Summary of Items Discussed in 5/2019 APSEC Discussion Forum on 22 November 2019

FRR Screen Wall and Unprotected Opening

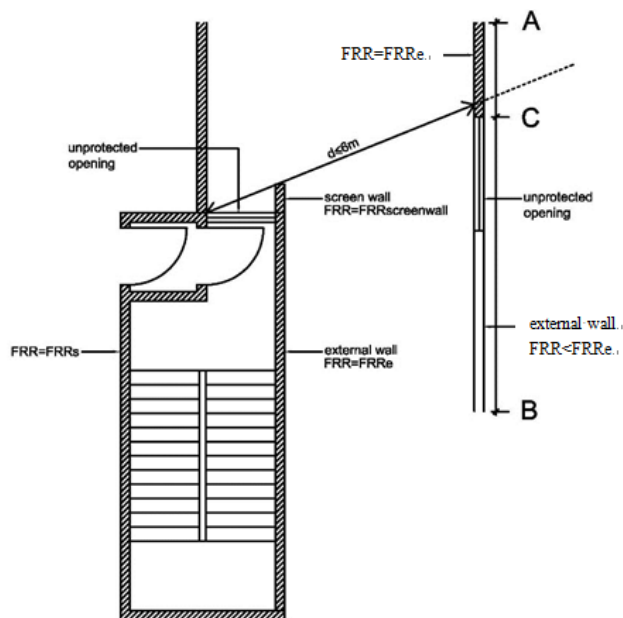
The corrigenda for FS Code 2011 issued in September 2013 refer. Example (b) was added to Diagram C2 with the addition of screen wall. Would BD please clarify whether the unprotected opening and external wall of $FRR < FRR_e$ (i.e. line BC as shown in the sketch below) at less than 6m from the unprotected opening of the required staircase is acceptable.

BD advised that where AB was the external wall of any other building on the same site with $d \leq 6m$, the window opening of the required staircase should be protected by fixed light with an $FRR \geq FRR_e$.

Where AB was any other external wall of the same building with $d \leq 6m$, whether the window opening of the required staircase could be unprotected would be considered on case basis, taking into account the actual configuration and distance between the unprotected opening at BC and the window opening of the required staircase, as well as the effectiveness of the FRR screen wall in protecting the staircase window opening.

Requirement of Thoroughfares

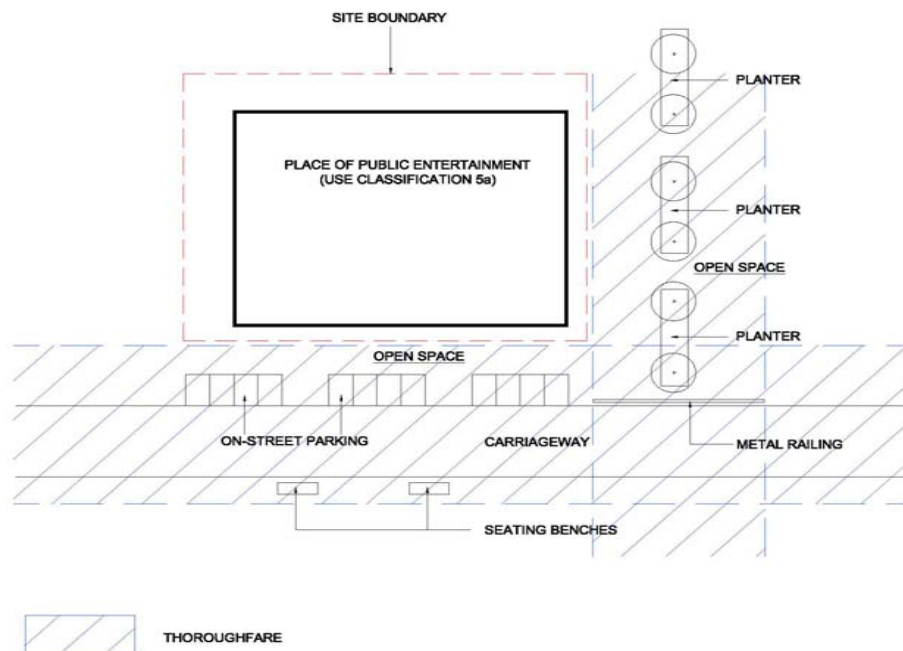
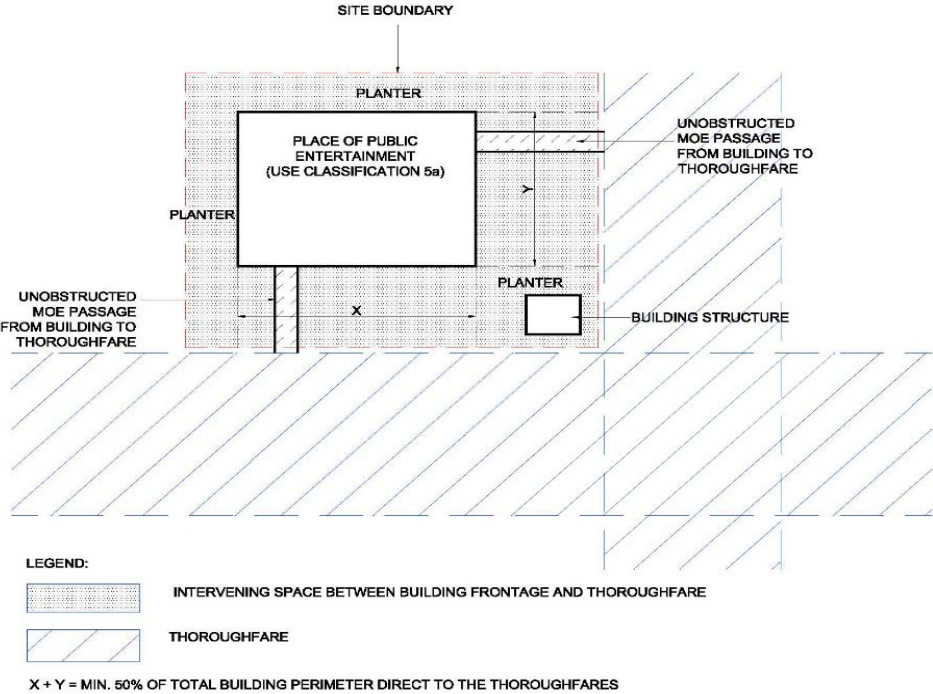
Clause B20.1 and B20.2 of FS Code 2011 require “The site of a Use Classification 5a should abut upon and have frontages to two or more thoroughfares” and “The frontage of a building having a Use Classification 5a should, subject to Clause B20.7, form at least one half of the total perimeter of the building excluding recesses and projection.....direct to

two or more thoroughfares.” We understand that one of the primary functions of the thoroughfares is for the purpose of MOE, as it is stated in Clause B20.3 of FS Code 2011 that “The thoroughfares in Clause B20.2 should be of such width as will enable the persons.....to disperse rapidly in the event of fire.”

Thus, in the case of a thoroughfare which is not designed to serve as an EVA, would BD please advise/confirm the following:

- (i) Area occupied by amenity features/street furniture such as on-grade planters, lawn, benches, on-street parking spaces, etc. within the thoroughfare can be fully accountable for the required width of such thoroughfare as per the below diagram; and

- (i) BD advised that whether any amenity features/street furniture located within the thoroughfare could be fully accountable for the required width would be considered on case basis. In general, the required width of thoroughfares should not be reduced by amenity features/street furniture which would adversely affect the occupants to disperse rapidly in the event of fire.

(ii) Where the building is set back from the site boundary abutting the thoroughfares, it is acceptable to occupy the intervening spaces with planters and/or other building structures/features as per the below diagram, provided that MOE from the building leading direct to the thoroughfares are not obstructed.  LEGEND: INTERVENING SPACE BETWEEN BUILDING FRONTAGE AND THOROUGHFARE THOROUGHFARE X + Y = MIN. 50% OF TOTAL BUILDING PERIMETER DIRECT TO THE THOROUGHFARES	(ii) For the proposed MOE arrangement as illustrated in HKIA's sketch, the unobstructed MOE passage and the intervening spaces with planters should be open area and the MOE passage should be clearly defined with a width not less than 1.5m wide or the total required width of exit routes discharging into the area, whichever is greater. In addition, the frontage requirements stipulated under Clause B20.2 of FS Code 2011 should apply.

9.	<u>Exemption of GFA and SC for Covered Areas Underneath Lowest Balcony/Utility Platform</u>

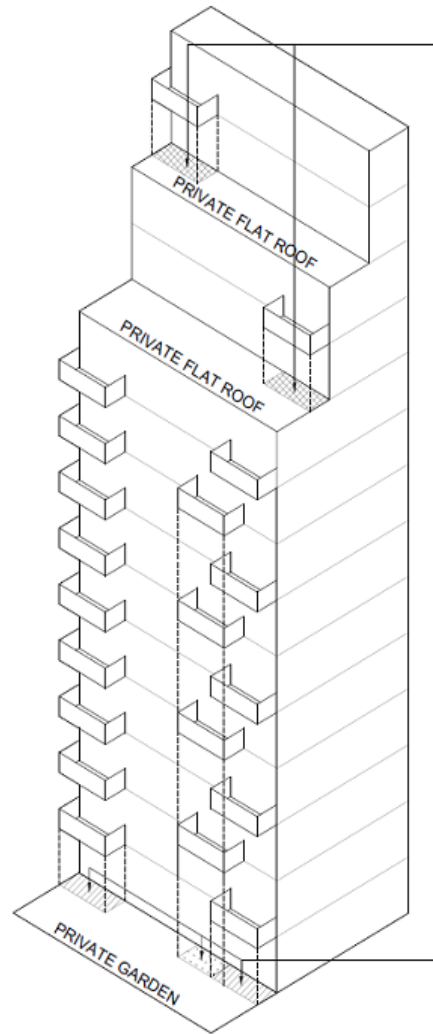
As stated in JPN No. 1 and No. 2, the covered areas underneath the lowest balcony and utility platform may be fully exempted from GFA and SC calculations, subject to fulfilment of certain design parameters. For situation where the upper portion of a domestic building is designed to have setback terraces/flat roofs at its upper storeys as per the below diagram (which design is not uncommon for providing, say, simplex or duplex units at the upper portion of a domestic tower), it may result in covered areas underneath balcony/utility platform over these private flat roofs at the upper portion of the building. Despite these covered areas are not located underneath the lowest balcony/utility platform of the building, we opine that they should still be fully exempted from GFA/SC calculations, as the arrangement is essentially similar to that described in the JPNs. Please advise if our understanding is correct.	Pursuant to JPN No. 1 and No. 2 jointly endorsed by BD, LandsD and PlanD, only the covered areas underneath the lowest balcony and utility platform might be fully exempted from GFA and SC calculations but not the covered areas at setback terraces/flat roofs at the upper domestic storeys as shown in the diagram.

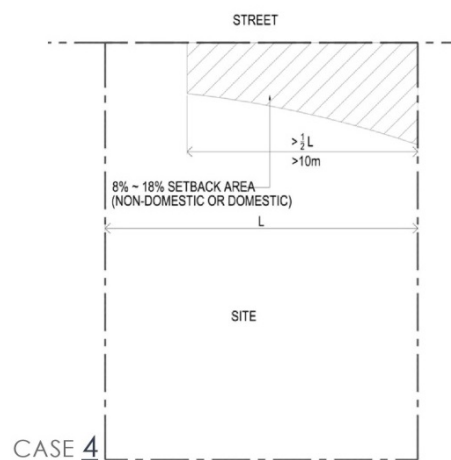
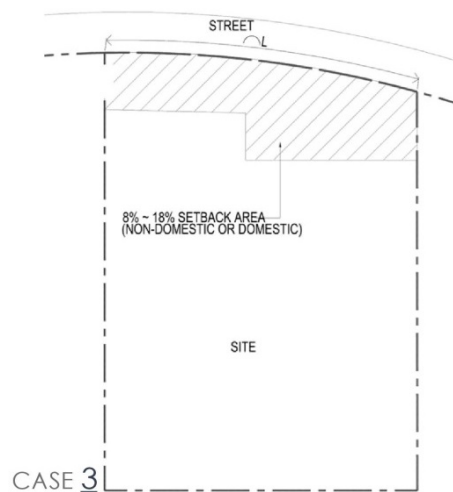
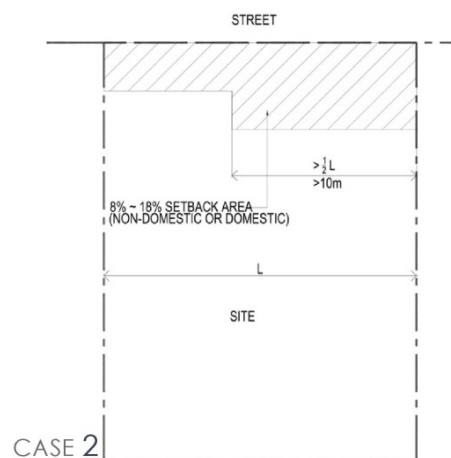
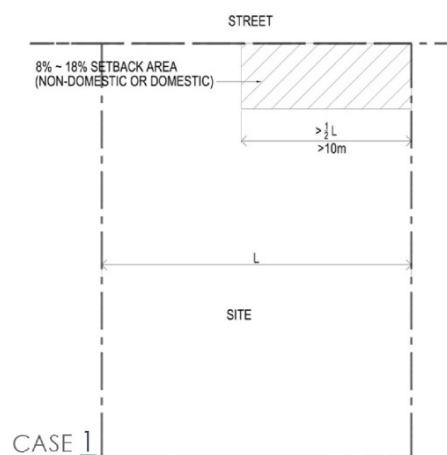
and not less than 10m long or the full frontage for site with frontage less than 10m in length” in considering applications for flexibility in determining site coverage and open space provision.

Please clarify whether our interpretation of paragraph 3(b) as demonstrated in the below 4 cases is correct.

ventilation and permeability as well as promoting connectivity and walkability. In this regard, setback in uniform design with a distinguishable space excluding non-functional pocket space would be favourably considered for calculation of the required setback area.

CASE 1A

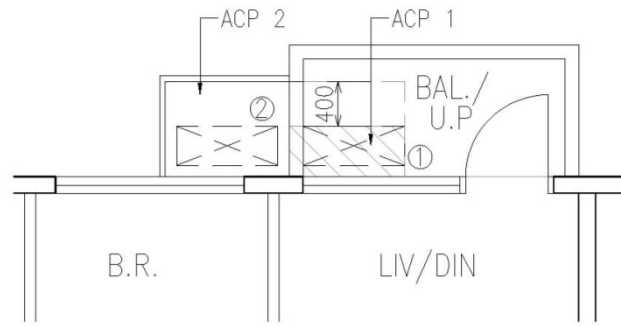
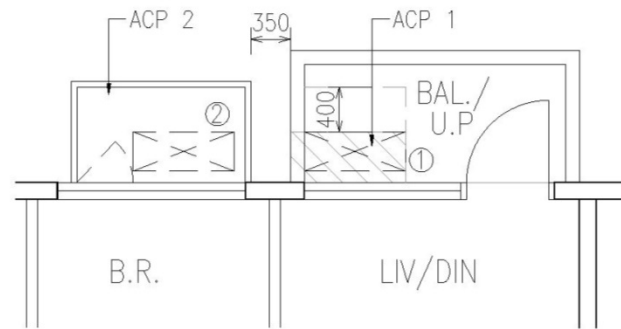
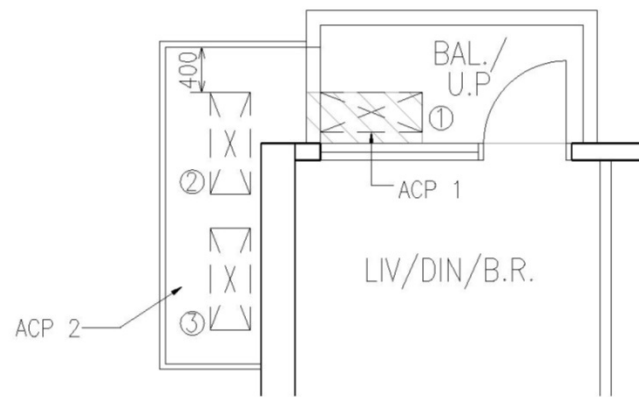
17.	<u>Code of Practice on Design for Safety – External Maintenance 2019</u> (i) According to the Appendix to BD’s Circular Letter dated 19.9.2019, Maintenance and Repair Access Plans (M&R Submission) should be submitted for BD’s approval prior to application for superstructure consent. Will BD accept the M&R Submission be submitted separately for BD’s approval prior to superstructure consent application, e.g. a technical report that includes those required technical specification like length of the cradle, tie-back restraints for suspended working platforms, etc.? (ii) According to paragraph (h)(ii) of Appendix B of the Code, is it correct only either of the design: (1) AC platform combined with balcony/utility platform or (2) individual AC platform, could be adopted in a development but not both? Will BD accept the following proposals?	(i) BD advised that paragraph 1(a) & (c) of the Appendix of the Circular Letter should be included in the GBP while paragraph 1(b) could be in the form of a technical report to be submitted for BD’s approval prior to superstructure consent application. (ii) If AC platform combined with balcony/utility platform had been adopted for a building, individual AC platform must not be erected at the external walls of the same building. For development with more than one building, each building of the development should be considered individually. In this regard, Case 1A, 1B and 2 provided in AAP’s sketches were not acceptable.

Figure 1: AC Platform in Balcony

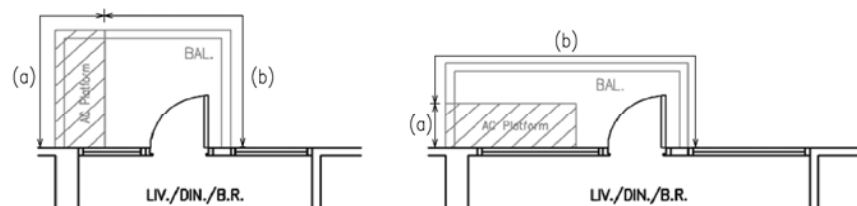
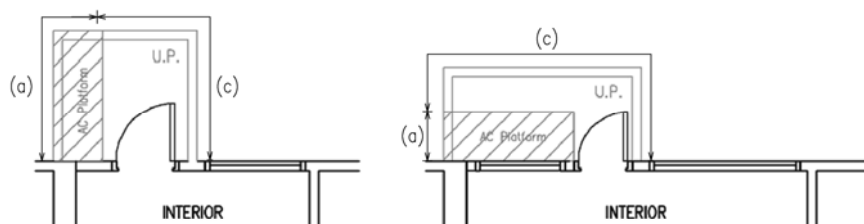
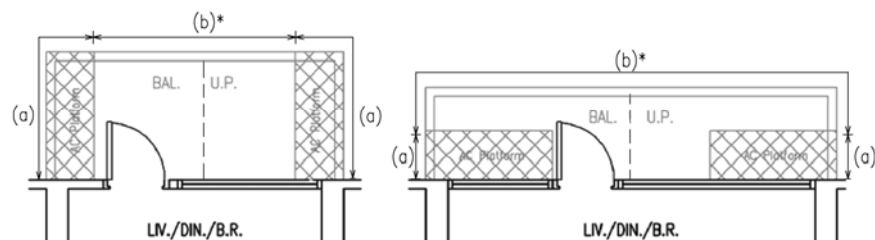
- (iii) For the Figures 1 to 3 under Appendix B of the Code, please confirm if our interpretation on the design of the protective barrier is correct.

- (iii) BD confirmed that AAP's interpretation was correct. Nevertheless, attention should be drawn to the requirements that the natural lighting and ventilation of the adjoining habitable space should not be obstructed by the AC outdoor units, and the open side requirement of balcony and utility platform under JPN No. 1 and No. 2 respectively should be complied with.

A further question was raised whether the short side of the AC platform if not for the purpose of air intake/exhaust could be changed to solid design. In response, BD advised that the matter would be further reviewed in the Technical Committee on the Code of Practice on Design for Safety – External Maintenance.

SCENARIO 1

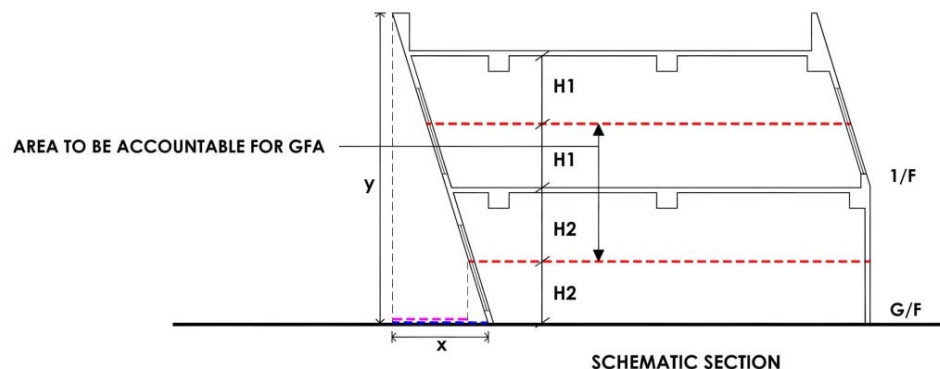
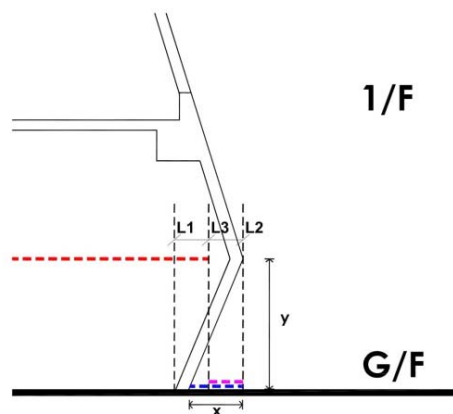
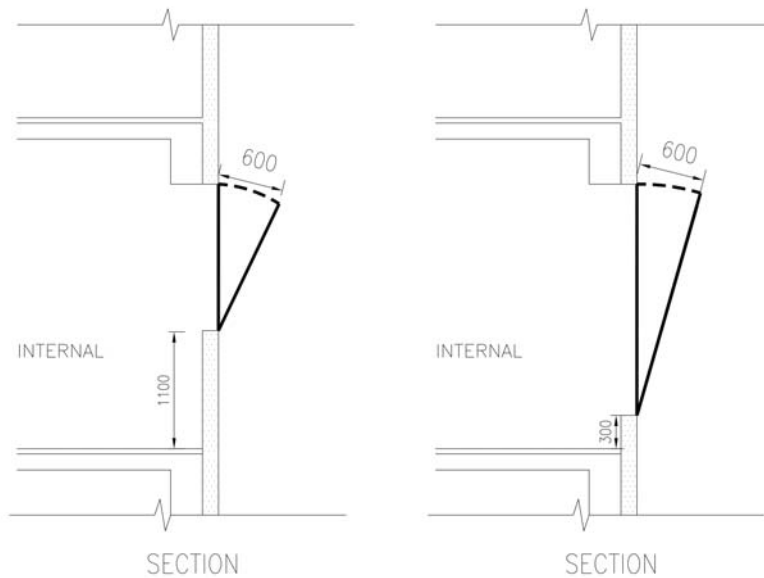
MEAN SITE FORMATION LEVEL $= \frac{X + Y}{2}$	
22.	<u>GFA Calculation for Inclined Building Form</u> It is becoming more common for AP to design innovative building form, e.g. twisted/inclined building due to advancement in building technology and better architectural expression. To facilitate AP to ascertain the basis of GFA calculation in early design stage, we would like to seek BD's confirmation on our interpretation of GFA calculation with respect to paragraphs 6 and 7 of PNAP APP-19 for inclined building form.	BD advised that the GFA calculation for inclined building form and any other innovative building designs would be considered pragmatically on a case basis. AP was encouraged to make use of the pre-submission enquiry service under PNAP ADM-19 to consult BD on the principle of GFA calculation for unconventional building design at early design stage.

23. Determination of Openable Window Area

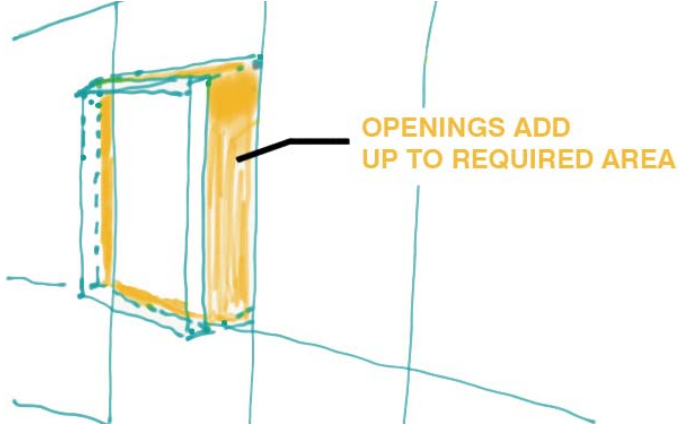
For openable bottom-hung window (Case A and Case B below), if the openable extent is not less than 600mm at the top of sash to window frame, its openable window area is to be calculated based on the elevation area of

Please clarify if, for some other special window like cassette-type window, the openable window area is the summation of all the openable areas (i.e. the gaps) on four sides of such window:

For bottom-hung window, BD confirmed that if the openable extent of the window was not less than 600mm, its openable window area should be calculated based on the elevation area of such window. In any case,

regulation 8 of Building (Construction) Regulations should also be compiled with where there was a difference in adjacent levels greater than 600mm.

By the same token, for cassette type of window, if there was 600mm or more clearance provided at the gaps, the openable window area could be calculated based on the elevation area of the window.
